Access Compliance Report Public Rights-of-Way (Curb Ramps)

Intersection ID: 10034966Main Street:PROVIDENCE_RD_WESTCross Street: N/ALocation:NWADA ID: 2D252403E056Ramp Type:Directional1Initial Pass/Fail: FailOverall Compliance: NoSeverity Score:12.5

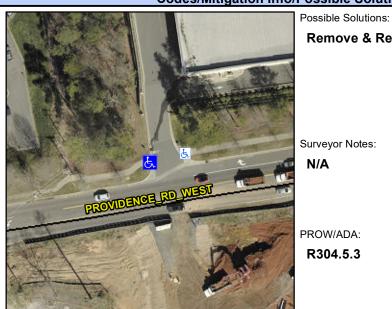
1 ossible colutions.				
Remove & Replace Entire Ramp.				
Surveyor Notes:				
N/A				
PROW/ADA:				
R304.5.3				
100-11010

Comp	liance Description	Data	Comp	oliance Description	Data
N/A	Ramp Length (in)	109.0	N/A	Grade Break?	N/A
Yes	Ramp Width (in)	69.0	N/A	Grade Break Slope (%)	0.0
Yes	Ramp Slope (%)	1.2	N/A	Grade Break XSlope (%)	0.0
No	Ramp XSlope (%)	5.4			
N/A	Flare Type LT	N/A	N/A	Flare Type RT	N/A
N/A	Flare Slope LT (%)	N/A	N/A	Flare Slope RT (%)	0.0
N/A	Flare Traversable LT?	N/A	N/A	Flare Traversable RT?	N/A
N/A	Landing Length (in)	0.0	N/A	DWS Provided?	N/A
N/A	Landing Width (in)	0.0	N/A	DWS Contrast?	N/A
N/A	Landing Slope (%)	0.0	N/A	DWS Length (in)	N/A
N/A	Landing X Slope (%)	0.0	N/A	DWS Full Width?	N/A
N/A	Landing Curb? (Y/N)	N/A	N/A	DWS Offset LT (in)	N/A
N/A	Shared Landing?	N/A	N/A	DWS Offset RT (in)	N/A
N/A	Gutter Ponding?	0.0	N/A	Gutter Slope (%)	N/A
N/A	Gutter Lip Ht (in)	0.0	N/A	Gutter X Slope (%)	N/A
N/A	Painted X Walk1?	No		Road Slope (%)	0.7
	X Walk 1 Direction	To NE		Road X Slope (%)	3.4
	X Walk 1 Width (in)	N/A	l	Clear Space?	N/A
